## **Service Bulletin**

**No. :** MZ05-013

**Model:** SM6100

**Subject:** Transistor upgrade.

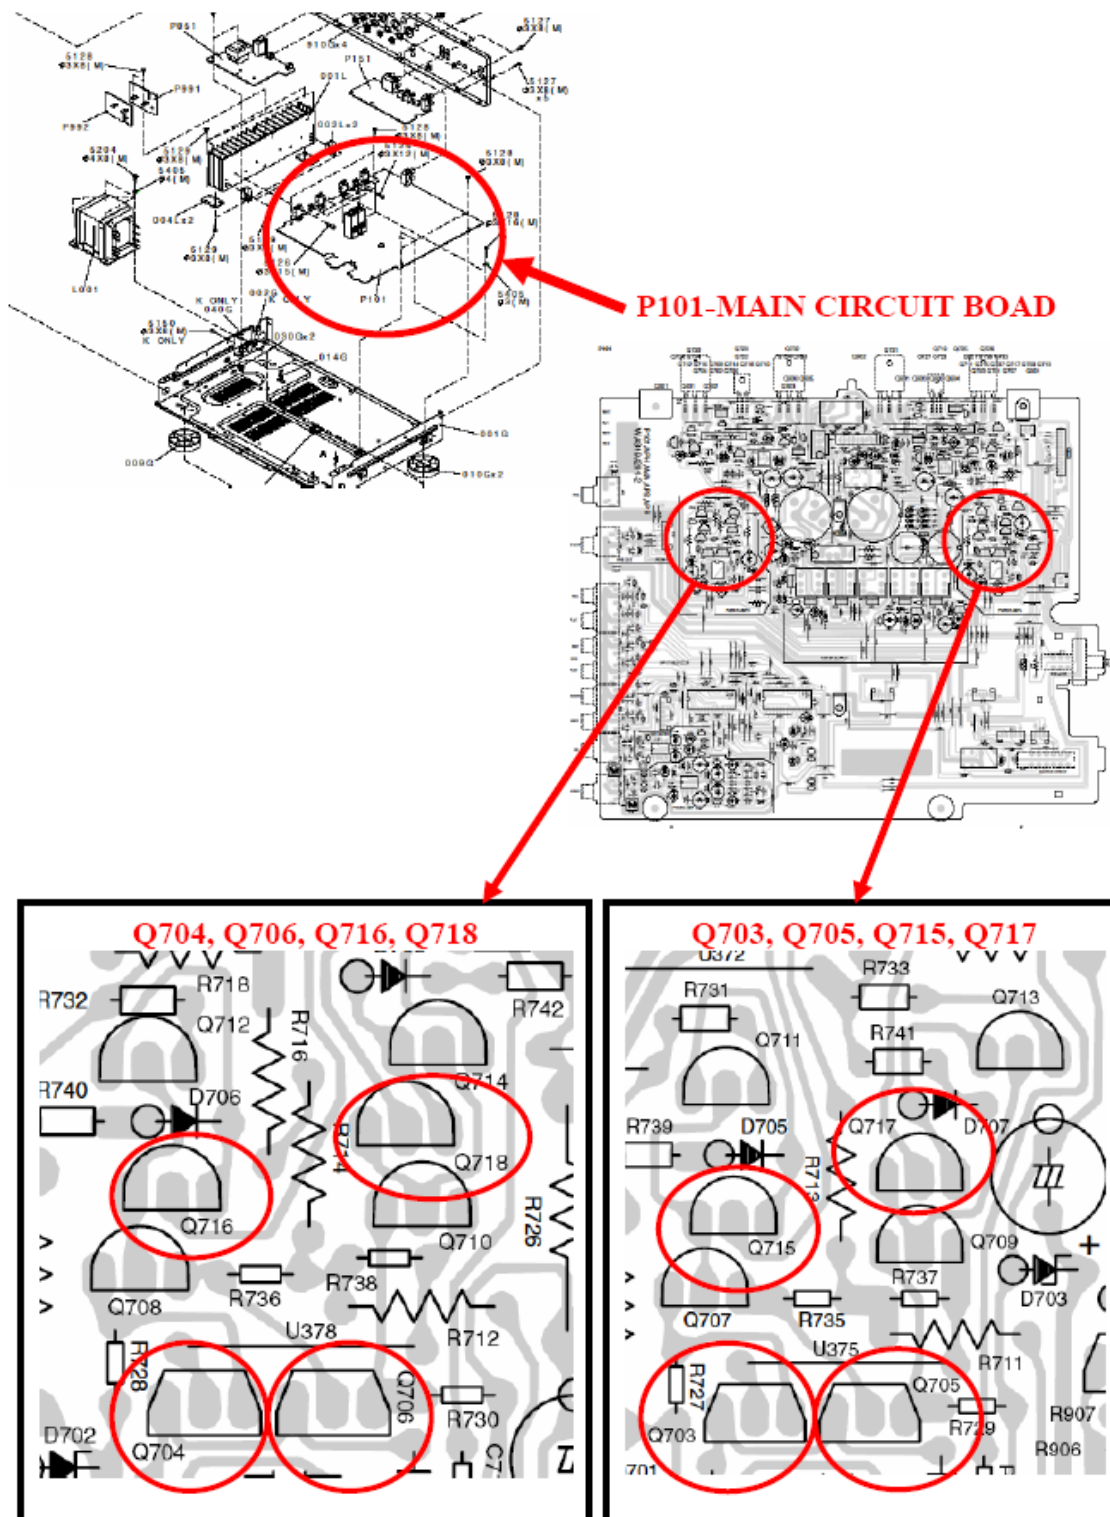
**Symptom:** Approximately 9mA current flows to transistor (from Q715 to Q718), and there is not enough margin in Pc (collector loss). Therefore, there is some possibility of a transistor failure through temperature rise.

**Solution:** Replace Q703, Q704, Q705, Q706, Q715, Q716, Q717 and Q718 on the P101-MAIN CIRCUIT BOARD with the improved transistors.
